STAFF REPORT

RE: Case No. CD-CPC-2019-00124

REQUEST: A request to approve an amendment to a development plan for a 14-story, 132 unit residential building with 2,135 square feet of retail space on a property zoned DX-15 (Downtown Mixed Use).

Figure 4. Initial Proposal to Activate Streetscape provided by applicant. It proposes two parking spaces for ride sharing services and food truck as well as some table and chair arrangement under street trees for seating (presumably for food truck customers).

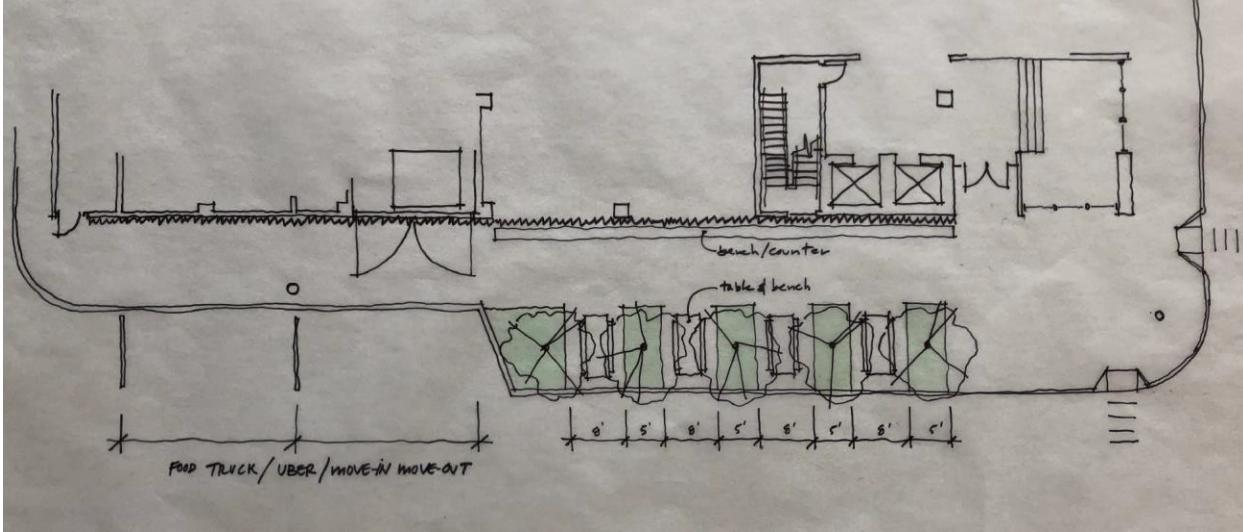
The developer, interested in pursuing an alternative within the right-of-way adjacent to their building, proposed standard improvements (replacing sidewalk and installing street trees) as well as working with Public Works Department to utilize some of the on-street parking spaces along Walnut in front of the building as a dedicated food truck space and widening the sidewalk further to add some seating and other amenities. The developer worked with staff to review various landscape and pedestrian amenity options for this section of Walnut Street. It was imperative that this section of the building be activated as well as sufficiently landscaped, to soften the harsh appearance of what was initially a blank wall and unlandscaped sidewalk. Figure 4 is what was presented to City Plan Commission in October 2018 and includes tables within the right of way. Figure 5 shows the design presented to City Council. The east façade includes light installation as well as bench seating, and significant tree plantings, which enhances the corridor and brings it back down to a pedestrian scale.

Figure 5. East façade pedestrian streetscape proposed 10/2018

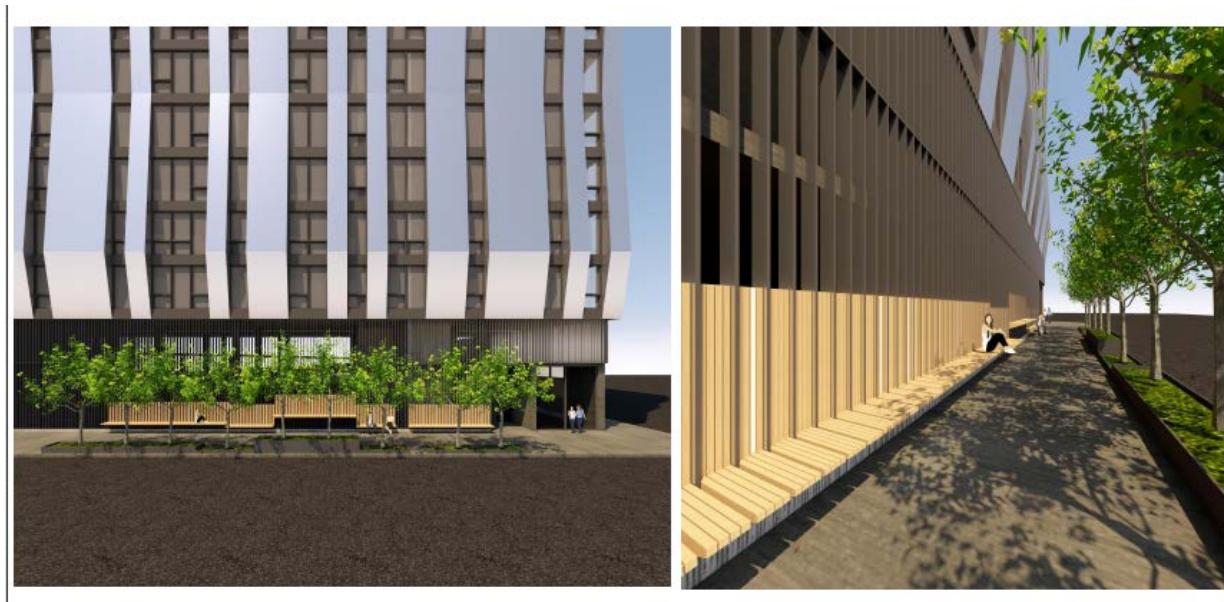
The plans presented in this revision pare down the pedestrian amenities quite significantly and do much less to activate this section of Walnut Street. As can be seen in Figures 6 and 7, the bench along the eastern façade has been removed, the multiple trees have been decreased to fewer ornamental trees, and the seating has been changed to a singular wooden bench and a concrete bench with a wooden table.

- c. That the number of street trees and landscaping used to soften the pedestrian experience include a mixture of low-growing evergreen and deciduous plantings to withstand summer and winter conditions while maintain security and safety along the corridor.
